**ADDENDUM #1
 ROCK PARK RESTROOM
 BID #15/16-005 – PWP# WA-2015-255
 BIDS DUE NO LATER THAN: 1:45 PM ON AUGUST 26, 2015
 PUBLIC BID OPENING: 2:00 PM ON AUGUST 26, 2015**

This addendum is to notify all potential proposers of clarifications made to the Bid documents as stated below.

**Rock Park
Restroom and Storage Building**

ADA001

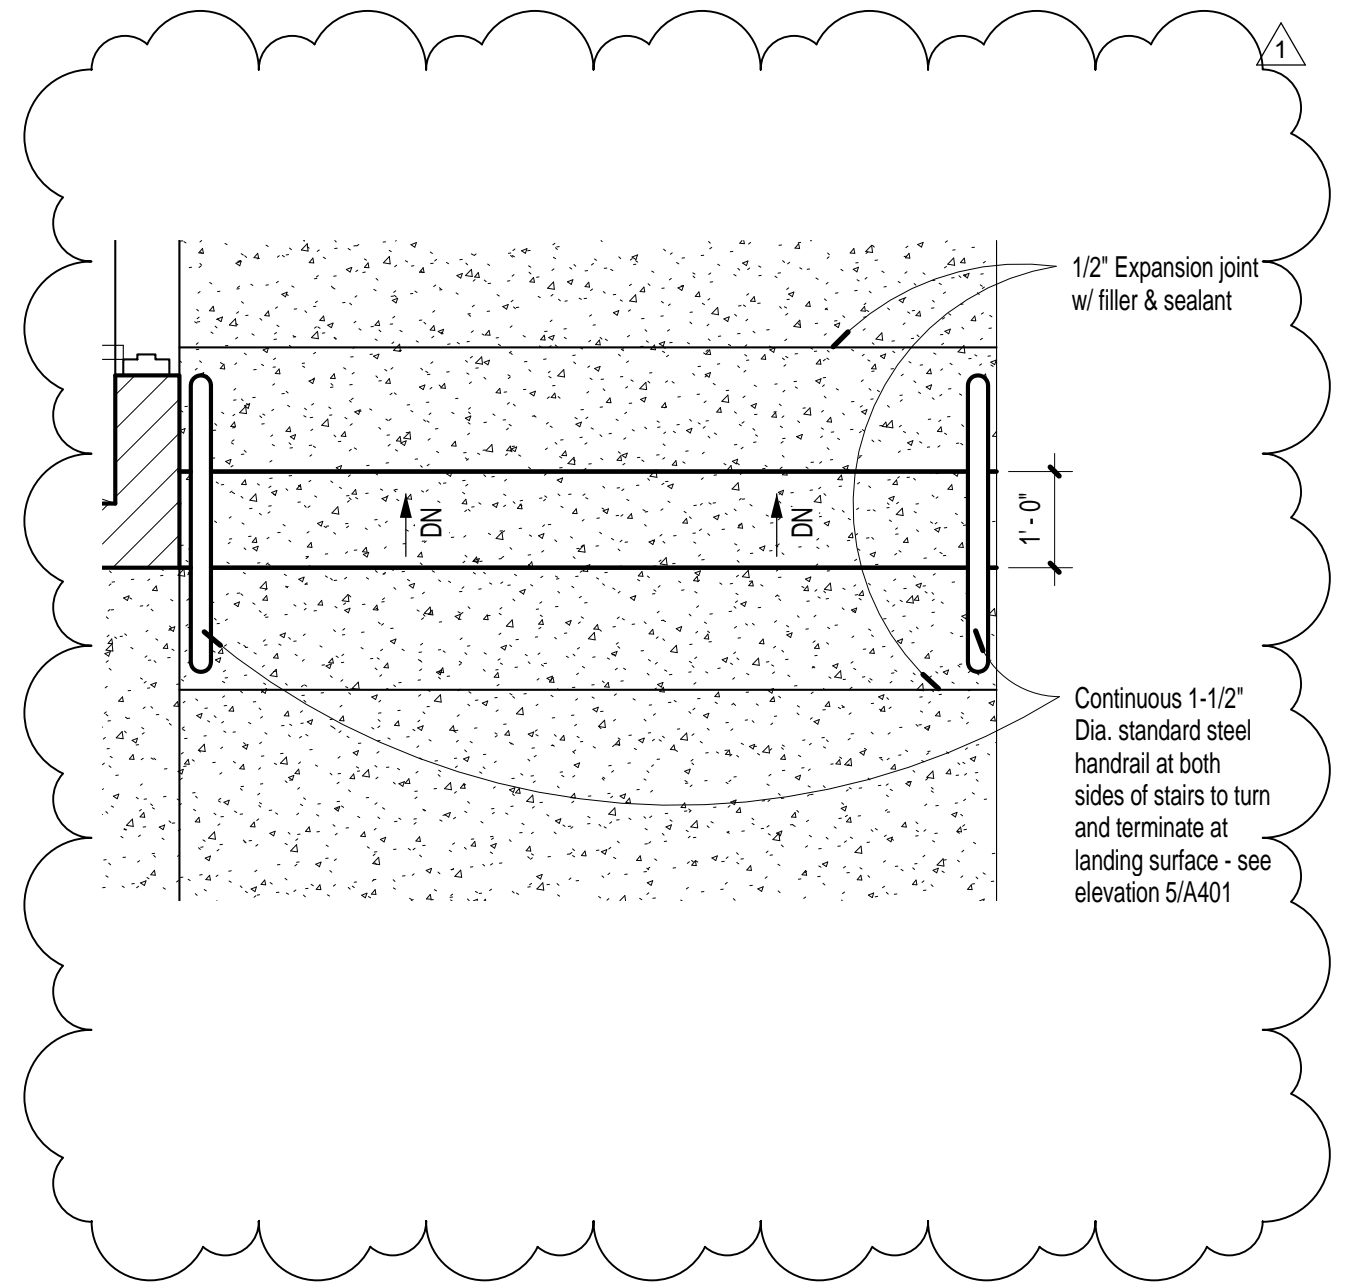
<u>SHEET</u>	<u>DESCRIPTION</u>
A401	Replace Details 4/A401 and 5/A401 with attached Addendum Drawing ADA001
E002	Added 30A circuit to Panel LA (22,24) for connection of sewer lift station.
E101	A/E101, New site background shown with electrical connections to sewer lift station (specified by Civil).

5 Typ. Concrete Steps on Grade - Addendum A001

4 Enlarged Plan @ Handrail - Addendum A001 North

Handrail at Stairs
